NL-20-0597
10 CFR 50.90
10 CFR 50.12ATTN: Document Control Desk
U. S. Nuclear Regulatory Commission
Washington, D. C. 20555-0001Vogtle Electric Generating Plant Units 1&2
Docket Nos. 50-424, 50-425Subject: Exemption Request and License Amendment Request for a Risk-Informed Resolution
to GSI-191

**Vogtle Electric Generating Plant
Licensing Submittal for a Risk-Informed Resolution of Generic Letter 2004-02**

Request for Exemption

Figure A3-1 – Corrected Enclosure 3, Figure 3-9 – Tornado Diagram Showing Risk Sensitivity Ranking

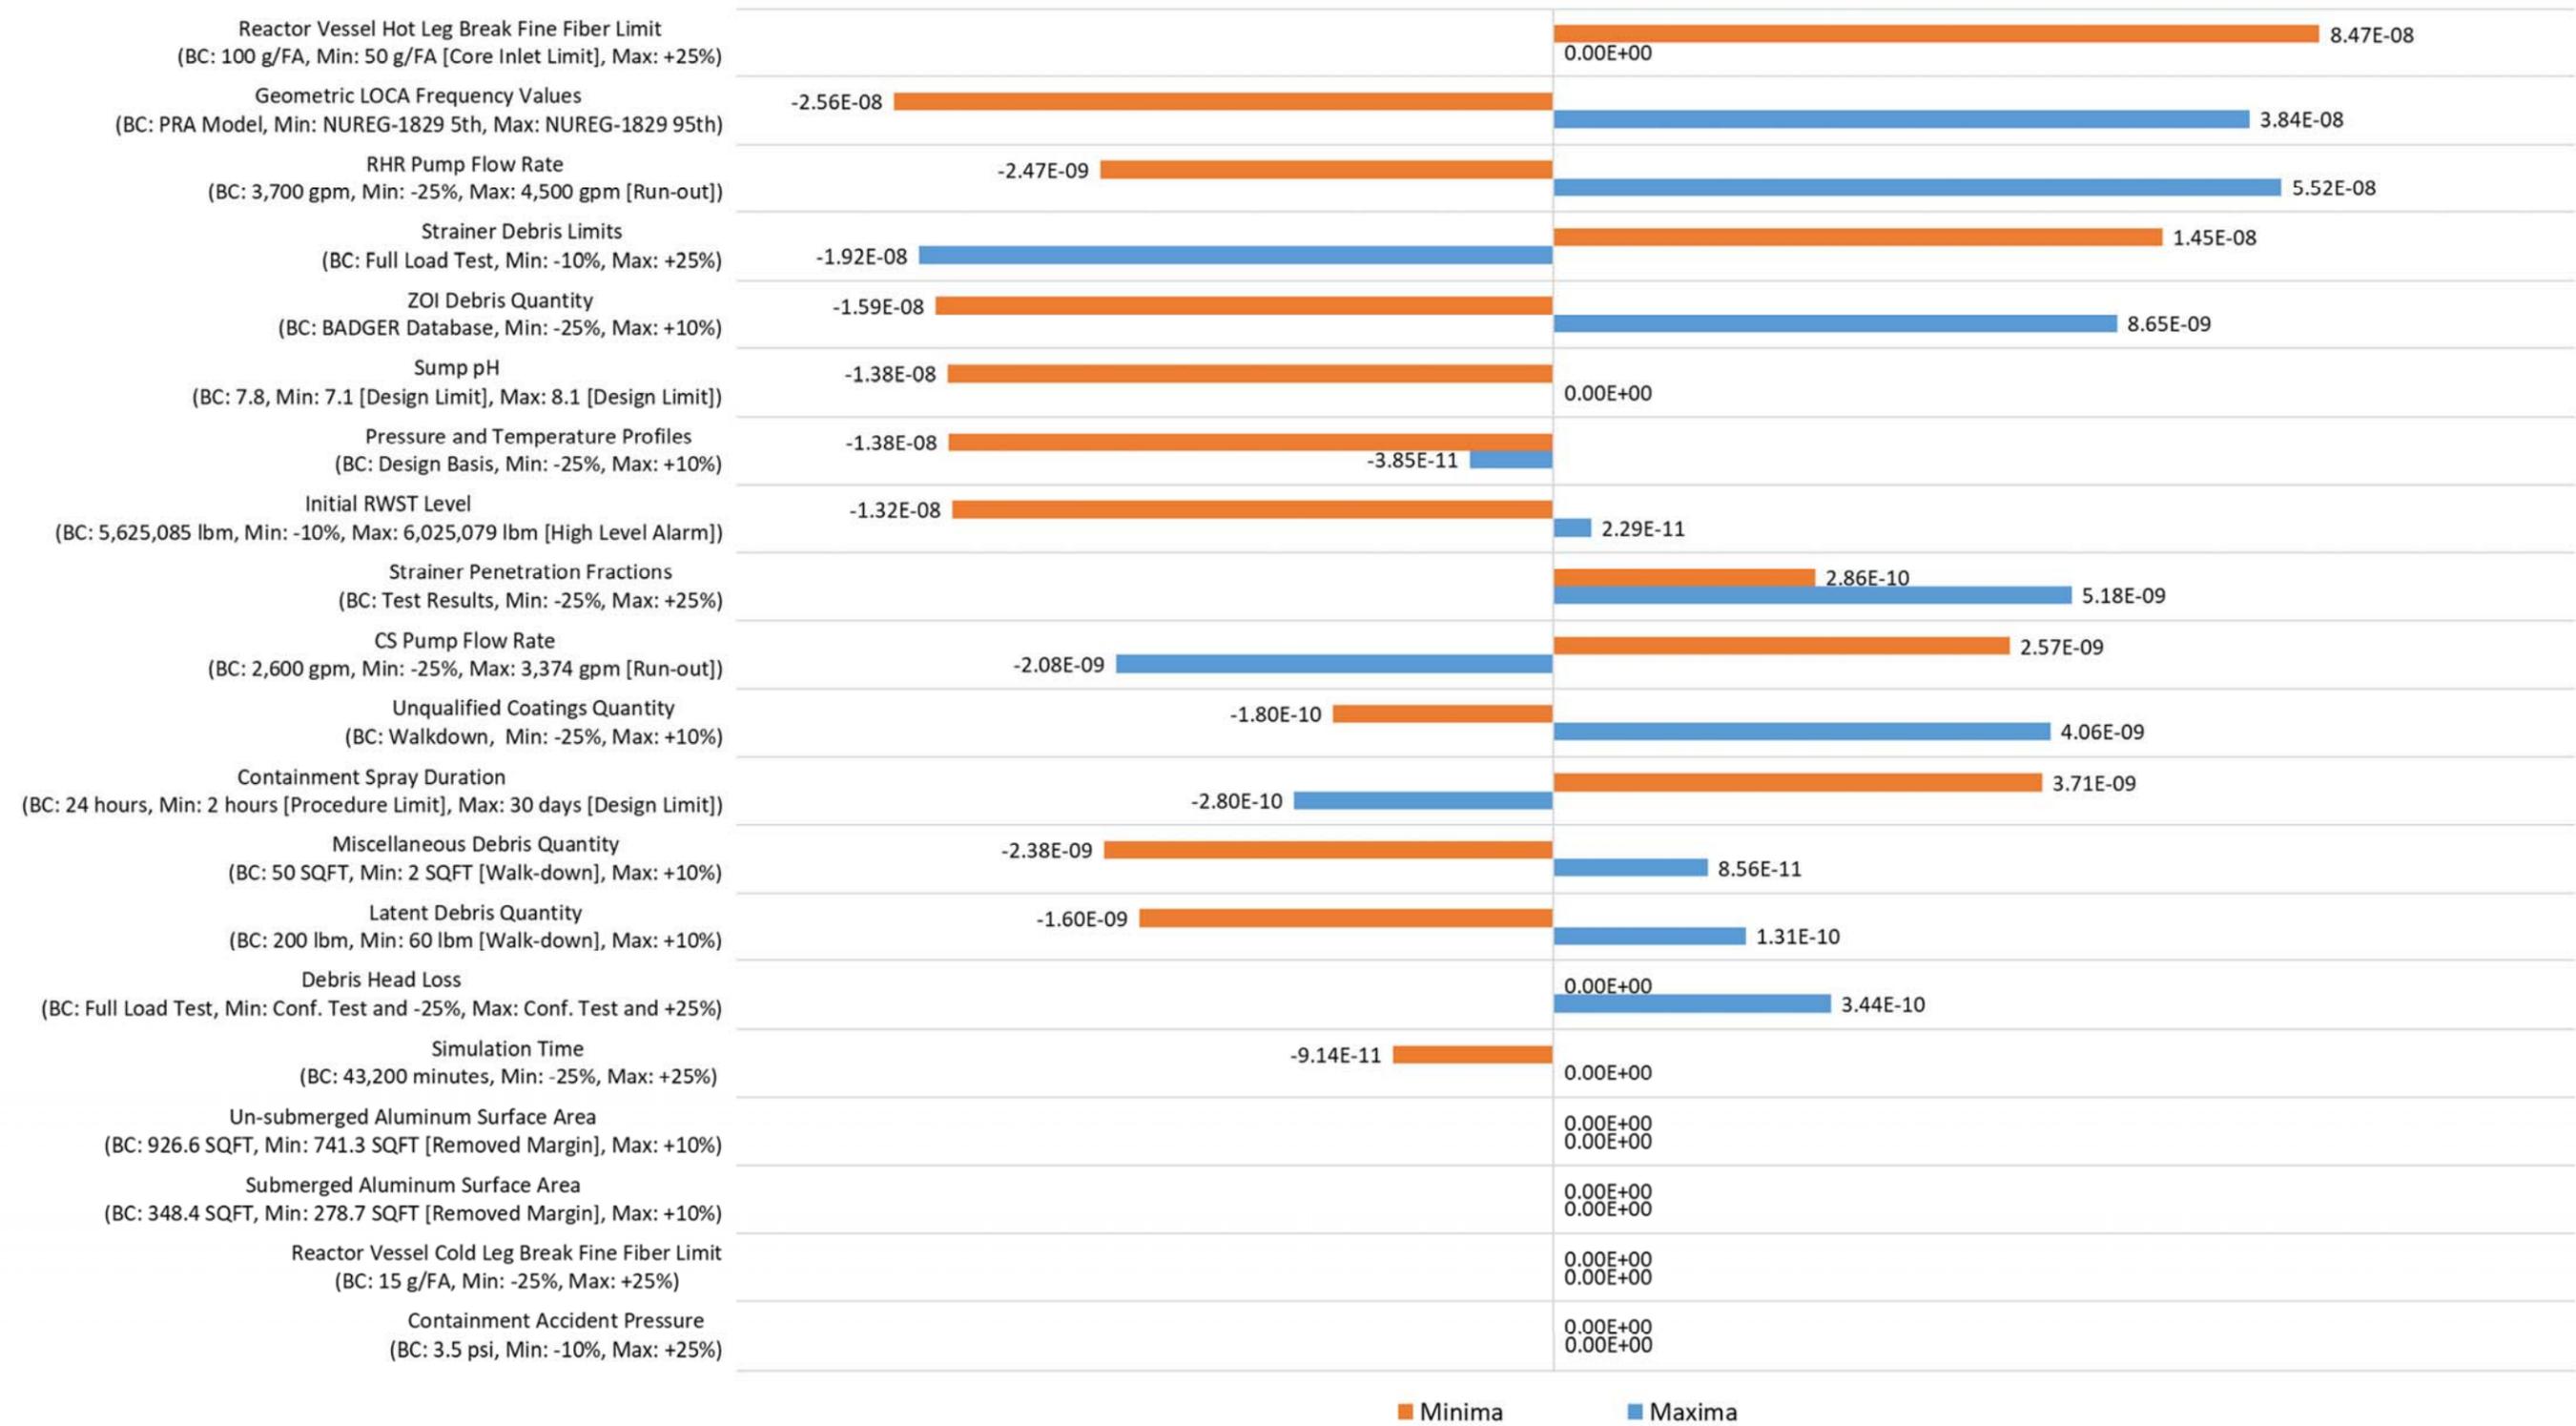
¹ Two typos were identified in Table 3-12 of Enclosure 3 in the July 2018 submittal (Reference 1). The Δ CDF values for the minimum and maximum “Strainer Debris Limits” sensitivity cases should have been 3.47E-08 and 5.31E-09, respectively (compared with the incorrect values shown in the submittal: 3.47E-07 and 5.31E-08). Correcting the coatings error increased the Δ CDF from 3.47E-08 to 4.01E-08 for the minimum input case, and from 5.31E-09 to 6.46E-09 for the maximum input case.

It should be noted that the Δ CDF values for the minimum initial RWST level and minimum particulate debris limit sensitivity cases were refined by eliminating the particulate debris limit failures for those breaks with a theoretical uniform fiber bed thickness less than 0.45 in. This approach is supported by the thin-bed head loss test results, which showed negligible head losses by particulates when the fiber bed thickness is equal to or less than 0.45 in (see Figure 3.f.10-4 in Enclosure 5 of the July 2018 submittal).

Figure A3-2 – Corrected Enclosure 3, Figure 3-10 – Comparison of Parametric Uncertainty Cases to the NARWHAL Base Case

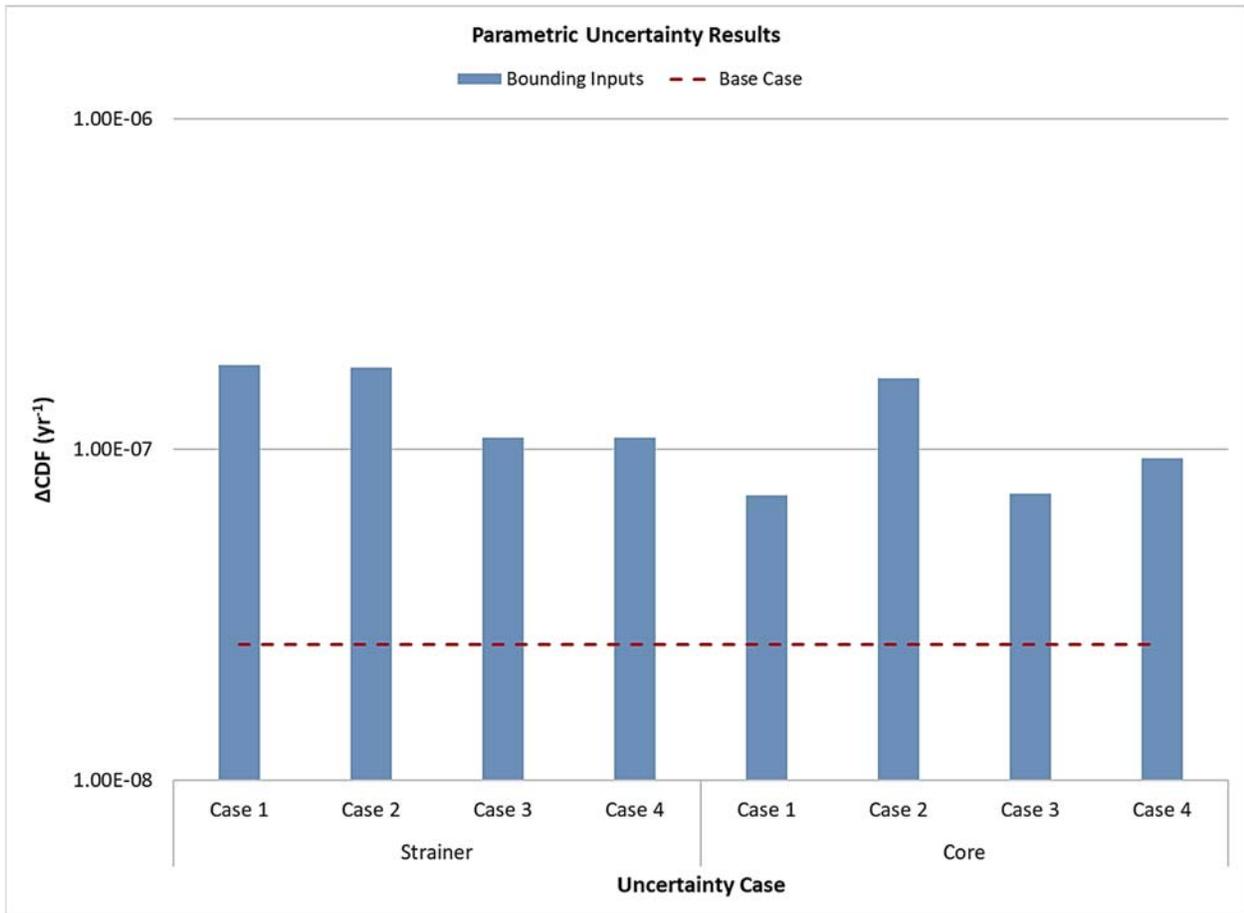
Table A3-10 – Corrected Enclosure 3, Table 3-15 – Results of Parametric Uncertainty Quantification

Figure A3-3 – Corrected Enclosure 3, Figure 3-11 – Comparison of Model Uncertainty Cases to the Base Case (1 of 2)

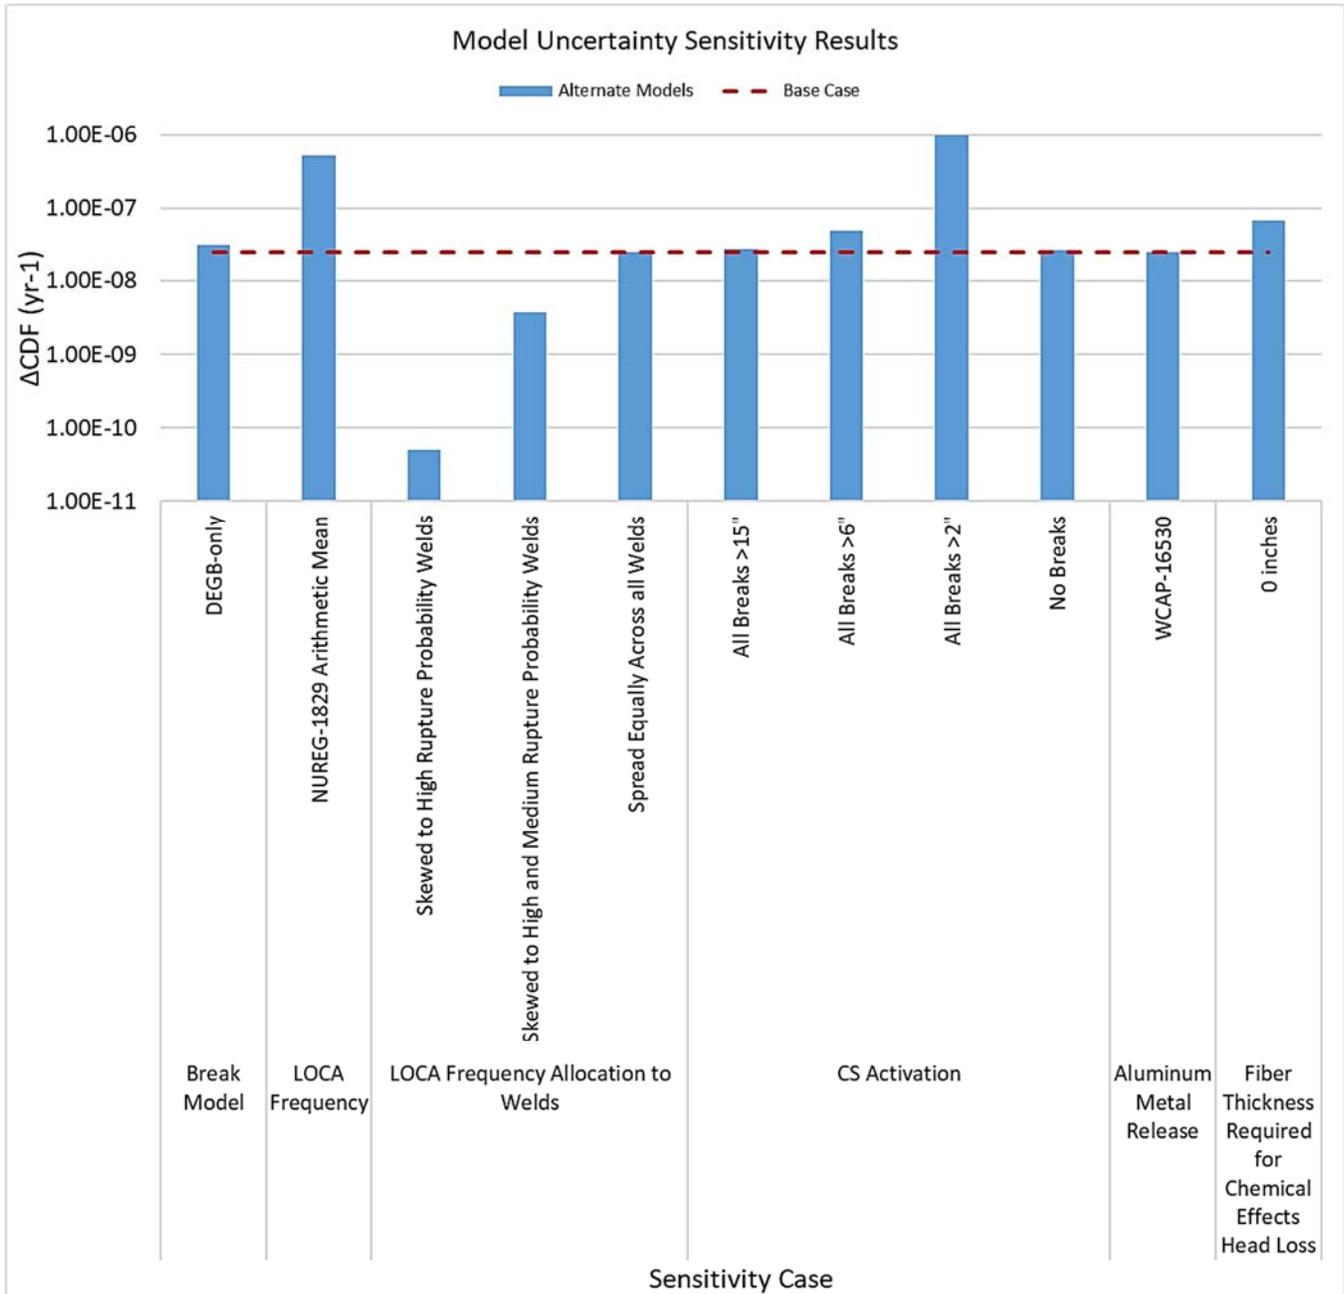
The results show that the Δ CDF for each of the parametric and model uncertainty cases is within Region III as defined in RG 1.174 (Reference 9). Therefore, it is concluded with high confidence that the risk associated with GSI-191 is very low as defined by the acceptance guidelines in RG 1.174. Correcting the coatings error does not change this conclusion from the July 2018 submittal (Reference 1).
